SUBJECT: NuScale Power, LLC Supplemental Response to NRC Request for Additional Information No. 28 (eRAI No. 8771) on the NuScale Design Certification Application

NuScale Supplemental Response to NRC Request for Additional Information eRAI No. 8771

NRC Question No.: 15-1

15.0.06 Return to Power

Figure 15.0-18: Reactor Power EDSS Available - Peak Power Case

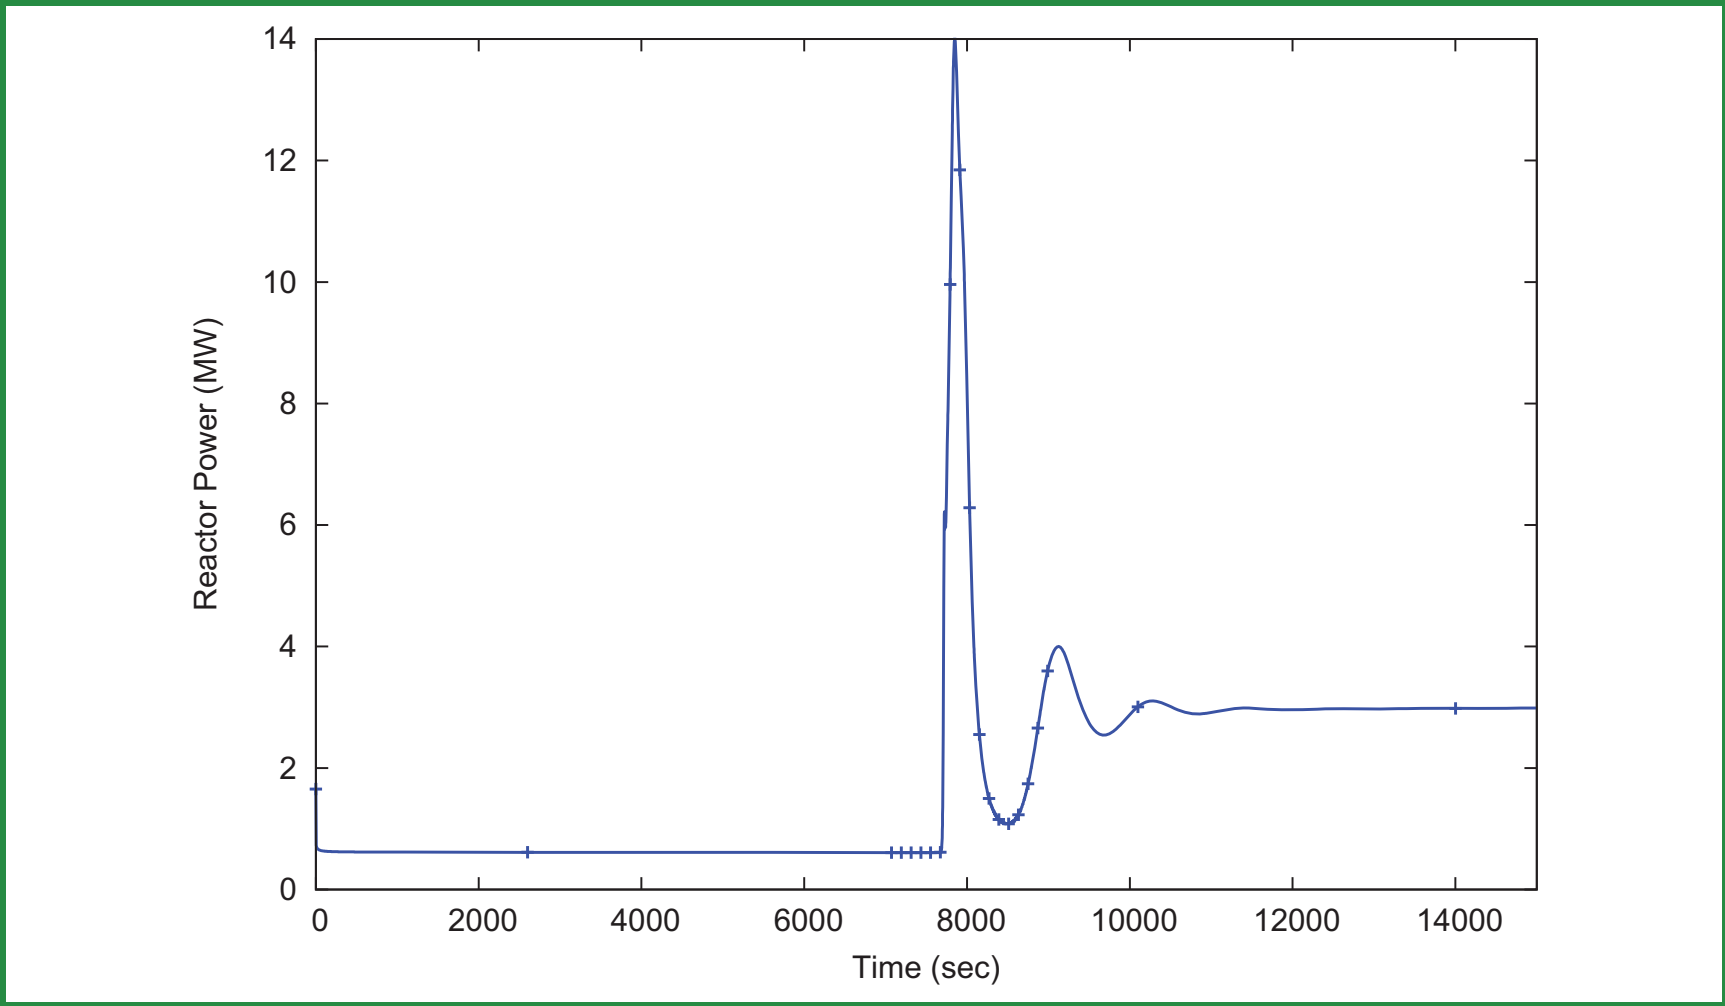
Based on the detail provided in Section 15.0.06, the staff is unable to reach a reasonable assurance finding that the SAFDLs will not be exceeded. The staff is requesting that Final Safety Analysis Report (FSAR) Section 15.0.06, which assumes the use of the decay heat removal system (DHRS), be modified to include details provided for a licensing basis event, and the short term transient analyses in the various subsections of Chapter 15 should reference Section 15.0.06 for the potential long term acceptability of the events. Additional information should include, but not be limited to, a description of the evaluation model(s); the critical heat flux (CHF) correlation used and basis for the correlation (or a reference there to); the assumed radial and axial power distributions and the basis for those power distributions (or a reference there to); and a justification of how reactor stability is maintained under these conditions such that the MCHF can be accurately determined. In addition to Figure 15.0-8, "Power Response on a Return to Power," the staff is requesting the FSAR be updated to include plots of reactor coolant system average temperature, pressurizer pressure, core reactivity, hot channel nuclear enthalpy rise factor (F-delta-H), and MCHF ratio versus time.

This response supplements the original response provided for this RAI question. In a December 5, 2017 public phone call to discuss the response to this RAI, the NRC staff indicated they believed the response only addressed one scenario associated with return to power upon ECCS actuation and not the return to power during the DHRS scenario.

In order to provide additional clarification, additional wording has been added to FSAR Section 15.0.6 and two additional figures, Figure 15.0-18 peak power with EDSS available and Figure 15.0-19 for RCS flow with EDSS available have been incorporated.

For the peak power case, recriticality occurs at 6750 seconds and the peak power (14 MW) occurs at 7850 seconds. As the temperature of the RCS increases, power decreases until equilibrium power (3 MW) is reached at 12000 seconds. This scenario results in the highest power level but is not limiting for MCHFR or other parameters. RCS Power is shown in Figure 15.0-18 and RCS flow in Figure 15.0-19.
